UNITED STATES PATENT AND TRADEMARK OFFICE

Office Action Summary

10/068,230

VAUGHEY ET AL.

FIGURE 1

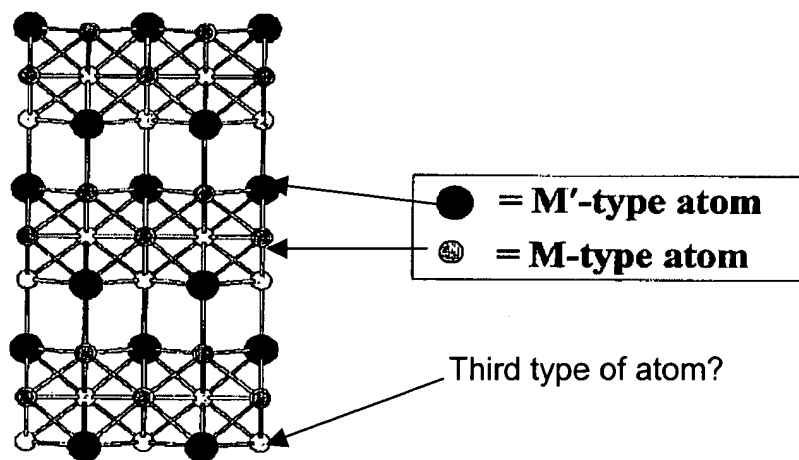
The drawings are objected to under 37 CFR 1.83(a) because they fail to show the structure of Cu_2Sb as described in the specification. Any structural detail that is essential for a proper understanding of the disclosed invention should be shown in the drawing. MPEP § 608.02(d). Applicants' illustration of a Cu_2Sb type structure in Figure 1 fails to provide details essential for a proper understanding of applicants' invention because only a two-dimensional view of the three dimensional structure is given, and the illustration appears to show three different types of atoms but identifies only two types, namely M' and M.

A proposed drawing correction or corrected drawings are required in reply to the Office action to avoid abandonment of the application. The objection to the drawings will not be held in abeyance.
